11/24/2004

RWCM Re-arrangements
S. Pordes

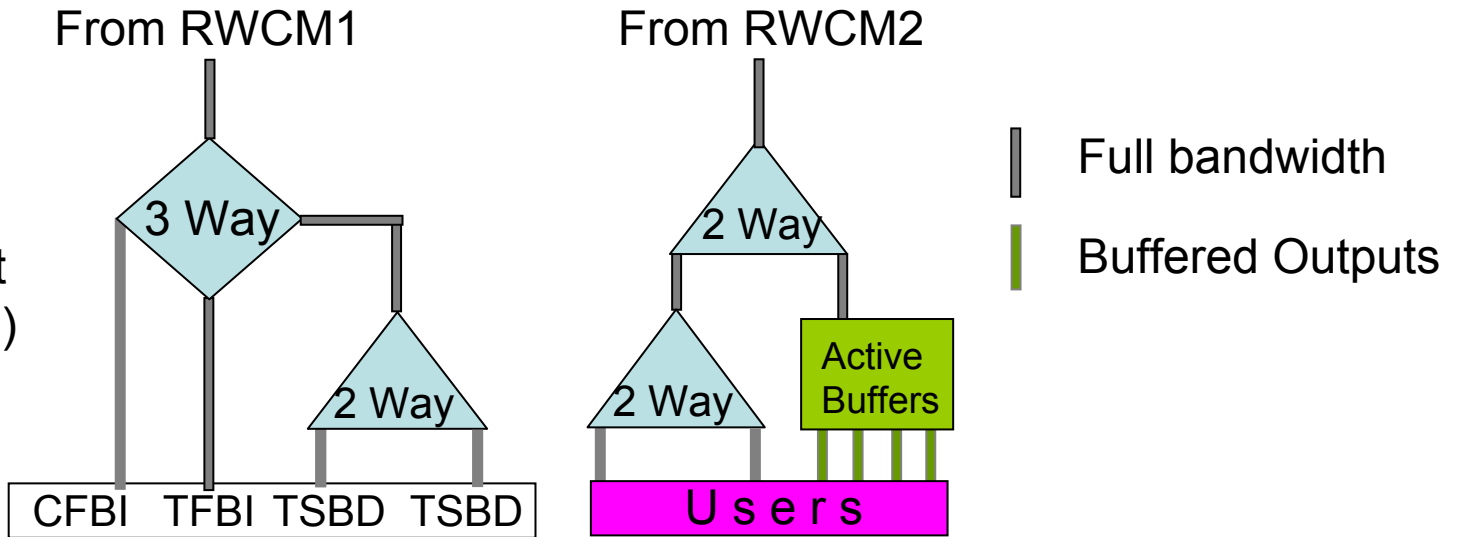
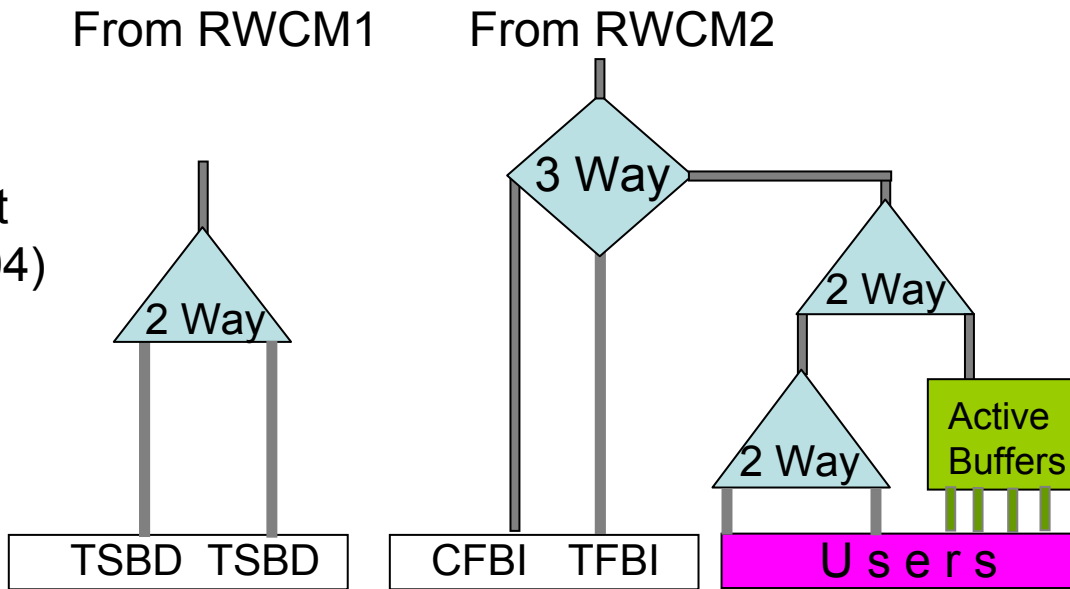
Previous Arrangement (pre 11/2004)

New Arrangement (after 11/2004)
